# Access Compliance Report

## Public Rights-of-Way

### (Curb Ramps)

Intersection ID: 10028420	Main Street: HIGHGROVE_ST	Cross Street: N/A	Location: SE
ADA ID: AC1FB59A6B97	Ramp Type: PerpDiag	Initial Pass/Fail: Fail	Overall Compliance: No
		Severity Score: 22.5

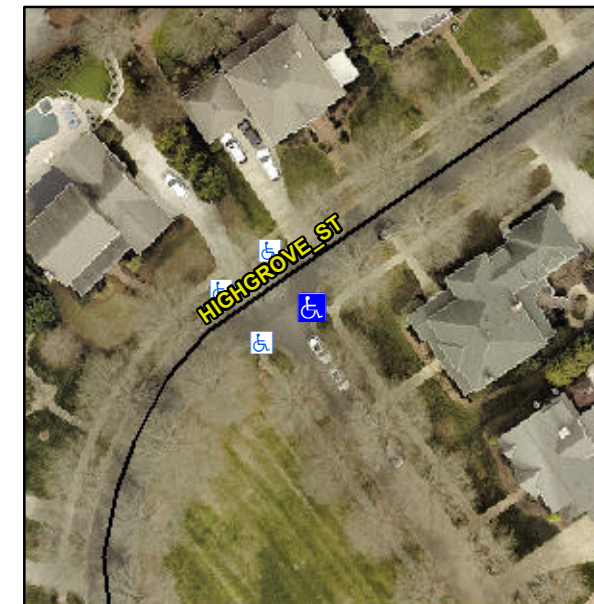
**R304.5.1, R304.2.2, R304.5.3**

Compliance	Description	Data	Compliance	Description	Data
N/A	Ramp Length (in)	102.0	No	Ramp Slope (%)	8.7
No	Ramp Width (in)	45.0	No	Ramp XSlope (%)	3.1
N/A	Flare Type LT	N/A	N/A	Flare Type RT	N/A
N/A	Flare Slope LT (%)	N/A	N/A	Flare Slope RT (%)	N/A
N/A	Flare Traversable LT?	N/A	N/A	Flare Traversable RT?	N/A
N/A	Landing Length (in)	N/A	N/A	DWS Provided?	N/A
N/A	Landing Width (in)	N/A	N/A	DWS Contrast?	N/A
N/A	Landing Slope (%)	N/A	N/A	DWS Length (in)	N/A
N/A	Landing X Slope (%)	N/A	N/A	DWS Full Width?	N/A
N/A	Landing Curb? (Y/N)	N/A	N/A	DWS Offset (in)	N/A
N/A	Shared Landing?	N/A			
N/A	Gutter Ponding?	N/A	N/A	Gutter Slope (%)	N/A
N/A	Gutter Lip Ht (in)	N/A	N/A	Gutter X Slope (%)	N/A
N/A	Painted X Walk1?	No	N/A	Painted X Walk2?	No
	X Walk 1 Direction	To NW		X Walk 2 Direction	To SW
N/A	X Walk 1 Width (in)	N/A	N/A	X Walk 2 Width (in)	N/A
	X Walk 1 Slope (%)	3.8		X Walk 2 Slope (%)	6.0
	X Walk 1 X Slope (%)	5.5		X Walk 2 X Slope (%)	1.5

**Remove & Replace Curb Ramp With Two New Directional Ramps or Equivalent.**
